ST. TAMMANY PARISH COUNCIL

ORDINANCE CALENDAR NO: 6643

AN ORDINANCE AMENDING THE OFFICIAL ZONING MAP OF ST. TAMMANY PARISH, LA, TO RECLASSIFY A CERTAIN PARCEL LOCATED ON THE NORTH AND SOUTH SIDES OF M P PLANCHE ROAD, WEST OF LOUISIANA HIGHWAY 25; COVINGTON AND WHICH PROPERTY COMPRISES A TOTAL OF 134.73 ACRES OF LAND MORE OR LESS, FROM ITS PRESENT A-4 (SINGLE-FAMILY RESIDENTIAL DISTRICT) TO AN A-4 (SINGLE-FAMILY RESIDENTIAL DISTRICT) & PUD (PLANNED UNIT DEVELOPMENT OVERLAY) WARD 3, DISTRICT 3) (2020-2143-ZC)

ZONING STAFF REPORT

Figure 2

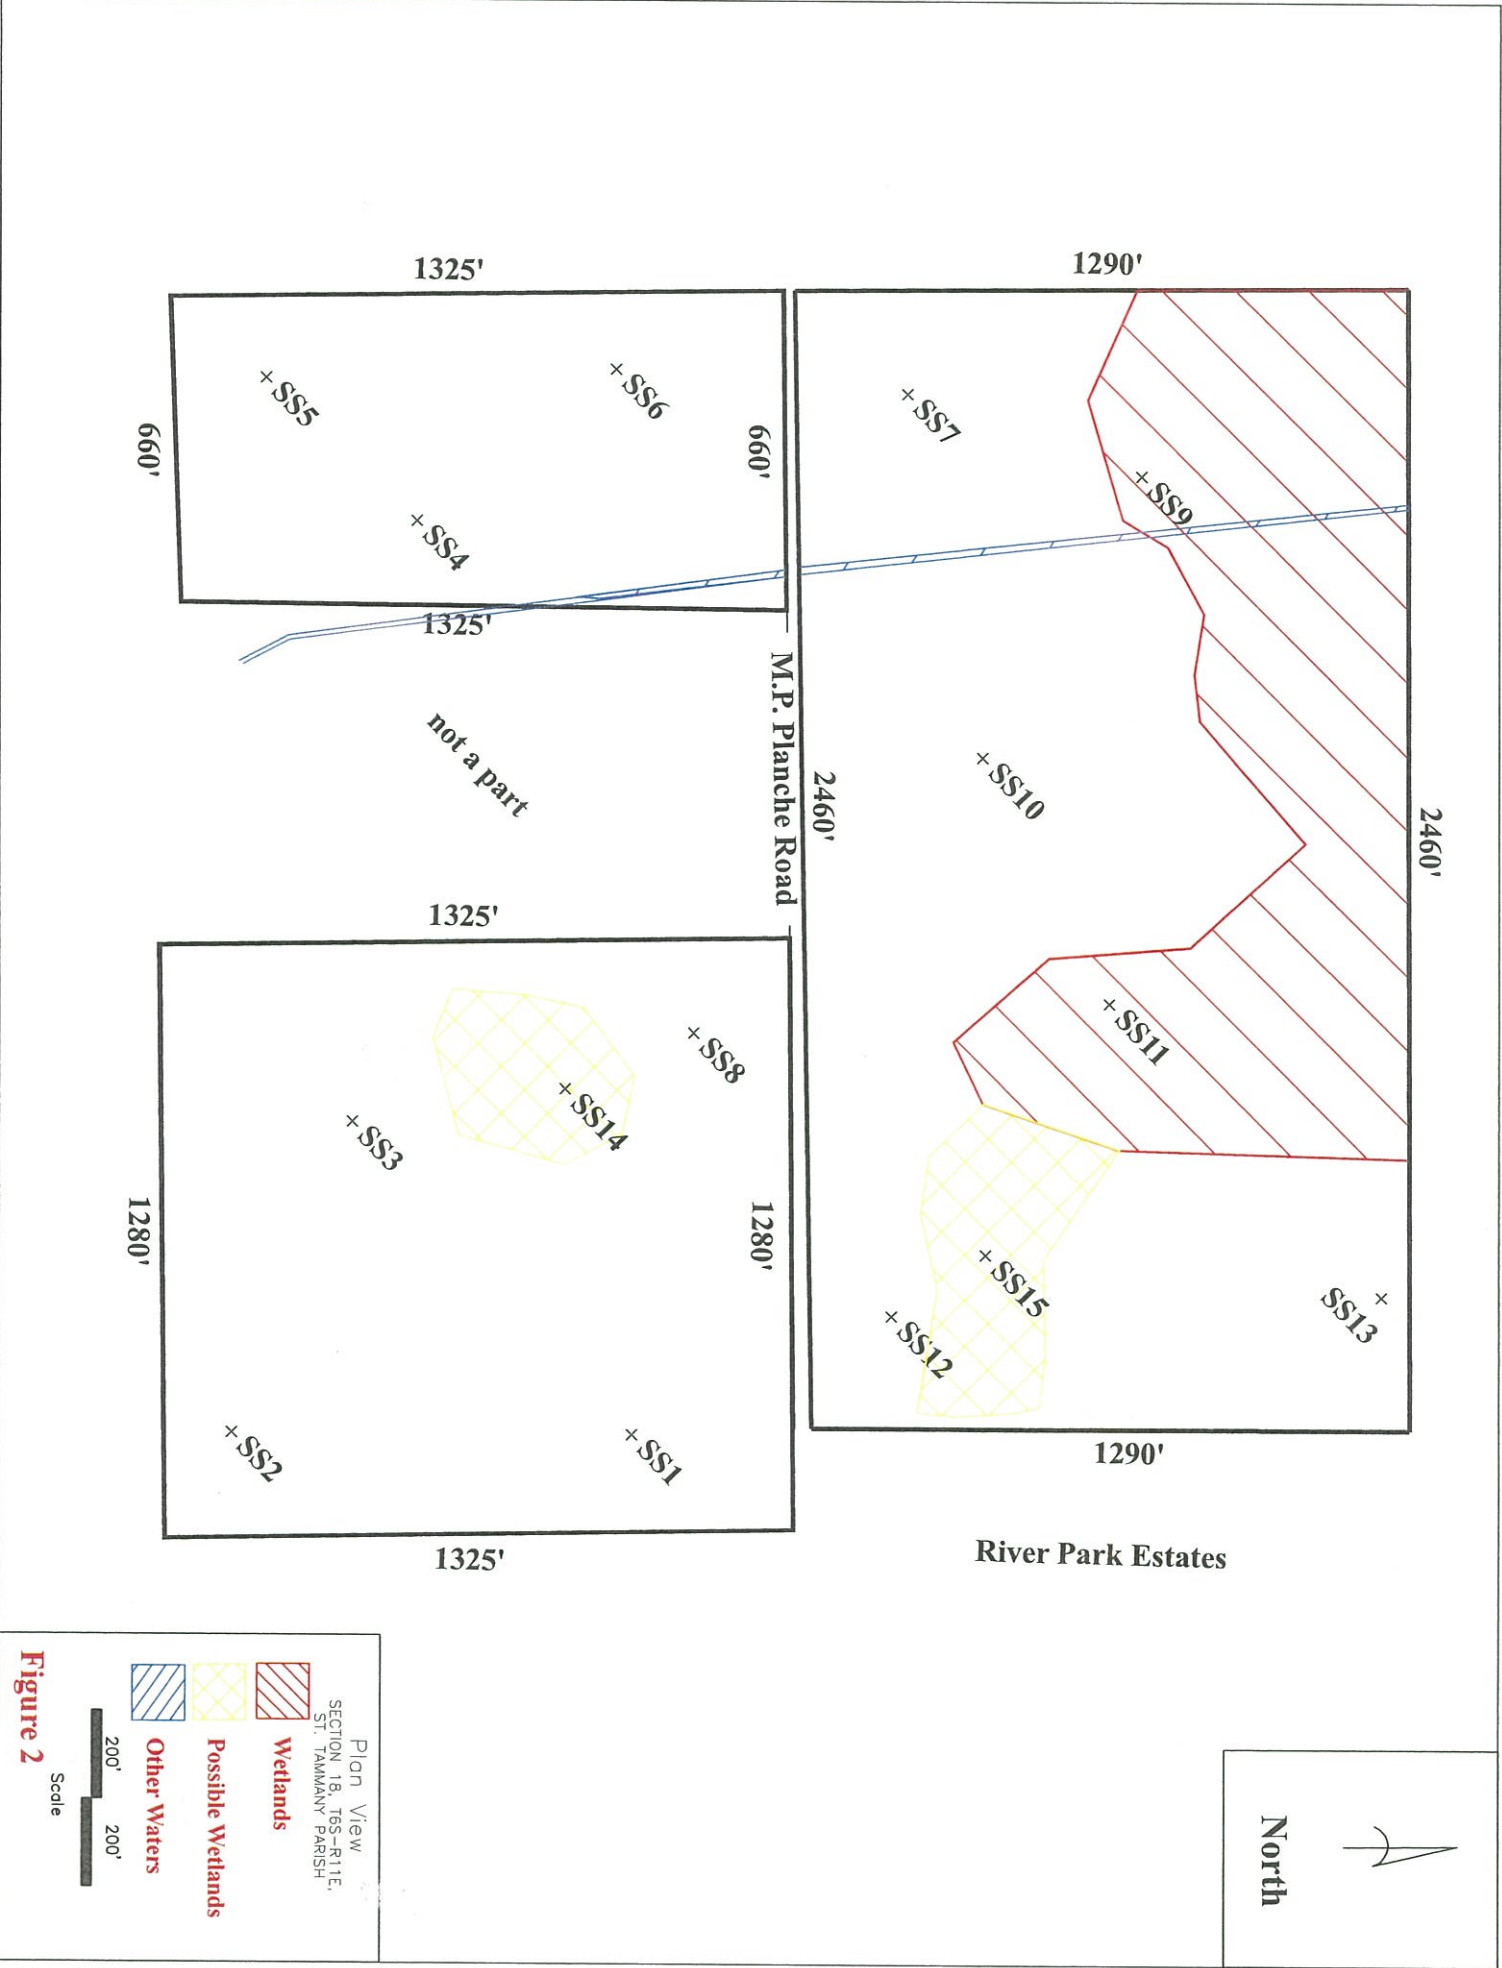
- The PUD plan shows 30.68 acres of wetlands to be maintained. Additionally, the plan is providing 11.72 acres of retention ponds.
- Informational Item: The Parish may adopt FEMA's Freeboard standard of BFE + 1 Foot by January 1, 2021. The applicant of this PUD may be required to implement the new standard after January 31, 2021.

- The proposed PUD plan provides for lots of similar size to be developed with single-family residential dwellings. The setbacks provided are uniform for all development. There is little diversification or variation of residential uses provided.
- The proposed PUD plan shows a majority of the 384 residential lots requiring a 25 ft. servitude within the entire rear yard from the building setback to the rear property line. As structures are not permitted within servitudes, this would result in no allowable fences, pools, sheds, play grounds or other typical structures found within a common backyard area.

- Almost 99% of the greenspace provided is passive in nature and is comprised of areas labeled wetlands. A total of 1.08 acres of usable open space areas labeled "basketball court" and "playground" is proposed to be provided. Considering the high density of the proposed subdivision, additional active areas and amenities should be provided.
- Per Sec. 130-1674(1)(8)(4), no more than 50% of the required open space shall be satisfied using land which is inundated by water more than four months out of the year. The applicant is proposing to use a majority of the existing wetlands to satisfy greenspace requirements. These wetlands are not programed for any form of recreation and have little formal access for the residents.

- Placing the greenspace areas and stormwater management ponds into a conservation easement would permanently limit the use of the land and ensure the public benefit of open space is maintained. The applicant has submitted a letter to the Department of Planning and Development which states no objection to placing the preserved wetlands at the north end of the project into a conservation easement prior to the recording of this section of the final plat.

- The 5.37-acre retention pond and park area to the northeast of the proposed PUD plan aligns with an existing 3.5-acre pond and park area to the west of River Park Estates Phase 1. The existing pond that was approved in River Park Estates Phase 1 and the proposed pond for River Park Estates Phase 3 are both dedicated to be maintained by St Tammany Parish. The applicant has submitted a letter of no objection to remove the berm along either retention ponds where they connect to combine the ponds and park space with input from the Parish Engineering Office. Merging the two ponds to form a larger, semi-regional retention pond could benefit stormwater management to reduce flood risk, facilitate maintenance, and maintain higher water quality. Additionally, merging the two ponds and park space could provide greater recreational opportunities and unified access to greenspace for residents.

- The applicant has stated that the proposed 384 home subdivision will be serviced by central sewer and water. Magnolia Water Utility Operating Company has stated that this capacity is beyond what is currently in place and any additional capacity could require a second treatment plant to expand.
- The section of the existing M P Planche Road is approximately 12 ft. wide where the proposed PUD is shown. While widening this section of the roadway will be required to match the existing approximately 16 ft. width of the eastern half of M P Planche Road, this is still substandard compared to the current Parish requirements for new roadways of a 20 ft. width.

- The proposed traffic circulation consists of one collector type road known as M P Planche Road which provides service to River Park Estates Phases 1 and 2, and River Park Crossing Phases 1 & 2. The proposed PUD plan shows forty-seven 60-foot-wide lots fronting this main access road. Allowing home sites to have direct access on M P Planche Road will requires residents to back onto a substandard collector road that is proposed to carry an additional capacity of 384 home sites, resulting result in adverse traffic circulation for the development.

2. The proposed 3.13-acre retention pond located in the southwestern corner of the proposed PUD appears to discharge into Horse Branch near its confluence with the Upper Tchefuncte River. This waterway is currently overburdened and stormwater runoff from this proposal may require a reduction of 25% for a 100-year storm event, pre-development.

4. The proposed density for this development is above the existing density in a majority of the surrounding area. Staff has determined that the proposal for 384 homes could create negative impacts on traffic, drainage, and safety. Additionally, the lot layouts that allow traffic to back onto M P Planche Road could cause traffic issues and safety concerns.

5. The proposed drainage servitudes will interfere with the useable portion of a majority of the lot’s backyard areas.
6. The applicant has stated no objection to placing the wetlands and retention ponds into a conservation easement.
